TECHNICAL BULLETIN

This bulletin refers to Ford Superduty trucks built 2017 and beyond (when a snowplow is operated a truck may experience following: radio shut down, instrument cluster backlighting inoperative, erratic climate control blower motor operation etc.)

QVM Bulletin: Q-277

Under Hood Electrical Equipment Mounting

Figure 1: 2017 Super Duty Under Hood Plan View. Low clearance to underside of hood in areas highlighted in orange

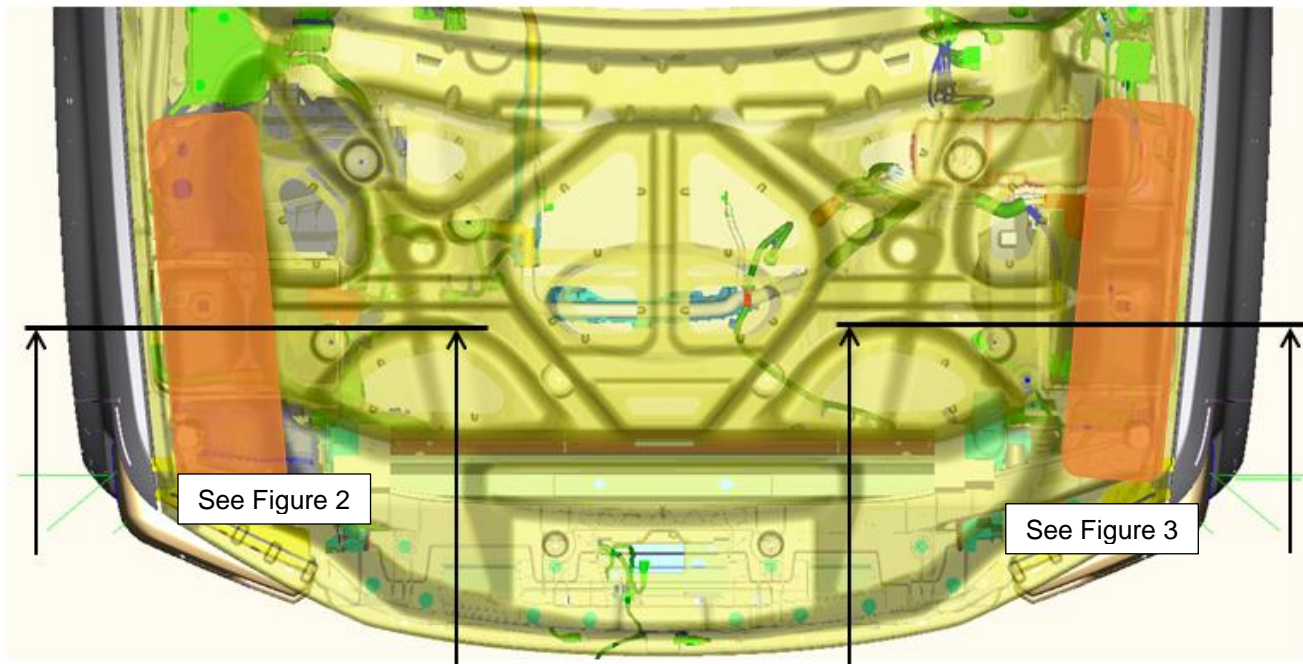
Do not mount or place electrical equipment, including but not limited to connection terminals, cables, relays, fuses, and fusible links on top of or near the primary or secondary battery in a location that has low clearance to the underside of the hood as indicated by orange rectangles in the figures that follow.

The reduced clearance to the underside of the hood for added electrical equipment on top of or near the primary or secondary battery may not be apparent when the hood is open. **If any B+ equipment is mounted in the low clearance zone as indicated by the diagram, a minimum of 15mm must be confirmed between bottom of hood and any equipment (including any B+ shielding and under hood insulation) mounted in the engine compartment when hood is fully closed.** Several methods exist to confirm equipment and shielding meets minimum clearance to bottom of hood (e.g. clay test, bore-scope).

The upfitter must ensure that any electrical equipment or shielding mounted under hood does not come into contact with the hood or hood components.

Figures 2 & 3: Vehicle X-Sections. low clearance areas (orange rectangles) for aftermarket equipment between battery & hood inner

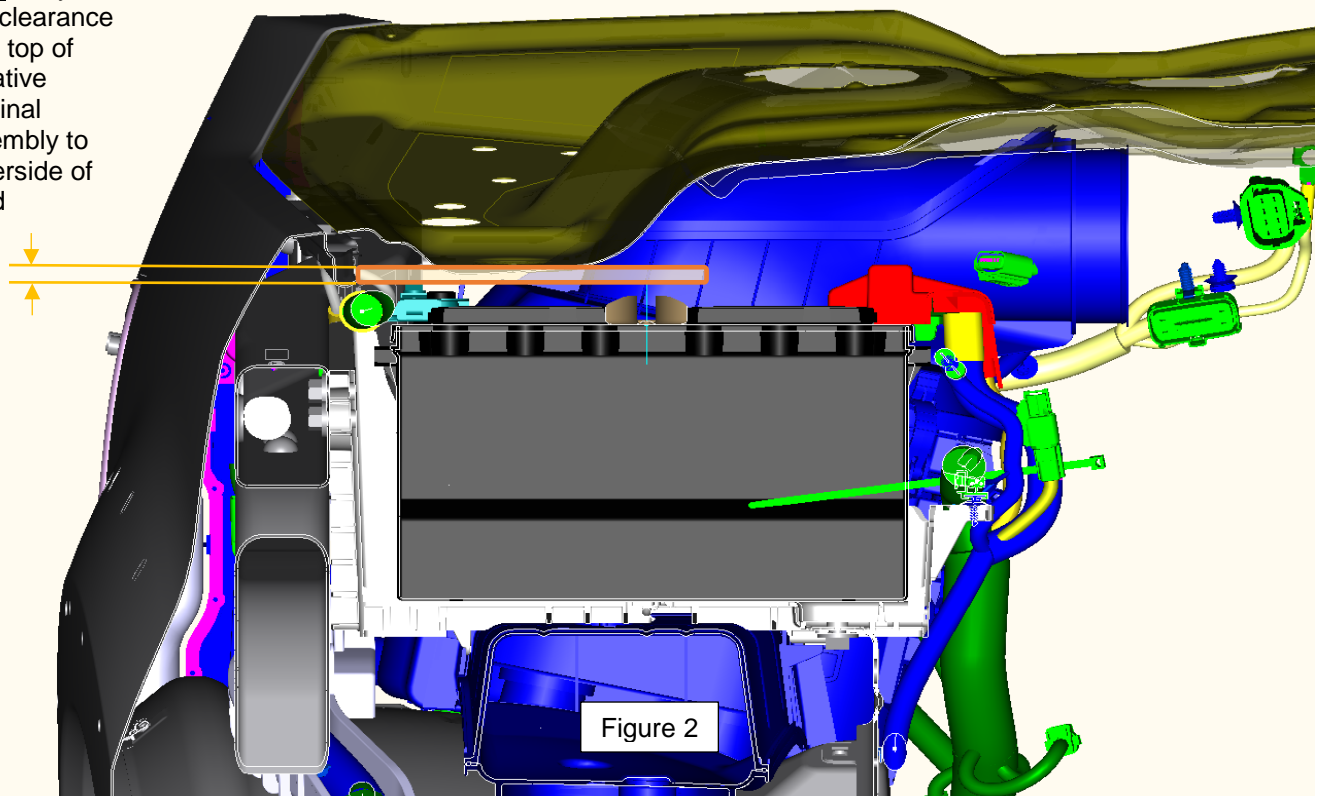
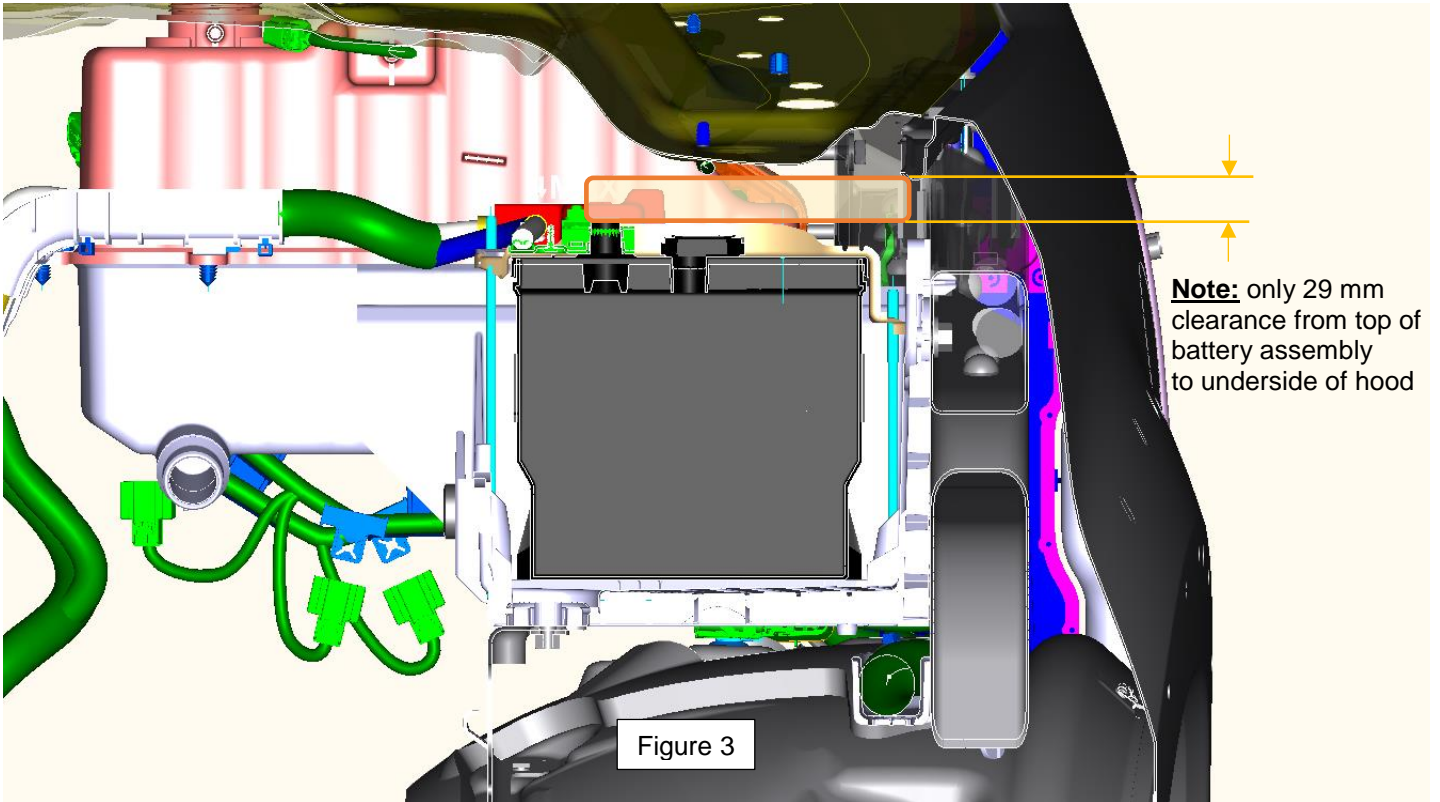
Note: only 16 mm clearance from top of negative terminal assembly to underside of hood

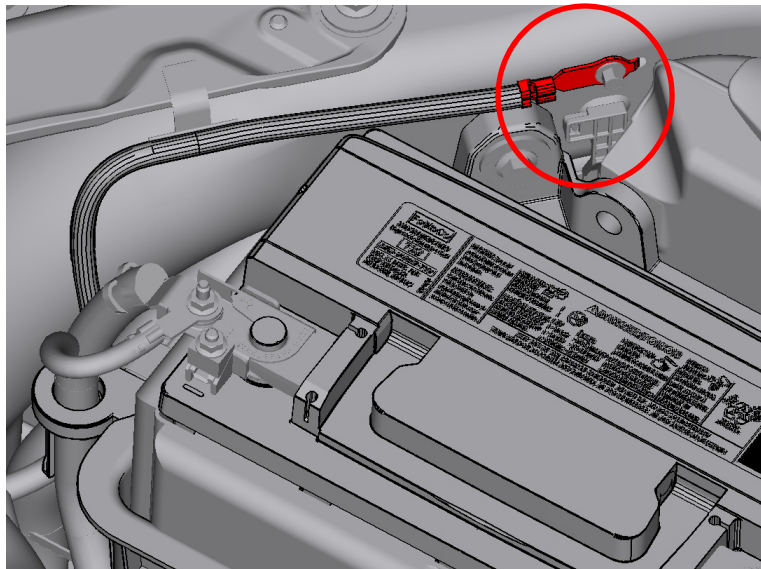
Description: The 2015MY F-150 battery charge state is determined with a Hall Effect sensor on the negative battery lead. All negative current must pass through this sensor. Failure to do so will result in malfunction of the vehicle charging system and shortened battery life. **Do not make direct to battery connections at the negative battery post.**

Procedure: To ensure proper charging system function, the battery return should be made at the grounding point shown and circled in red in the picture below:

Eyelet ID: 7mm
Bolt: M6
Torque: 9 +/- 1.4 Nm
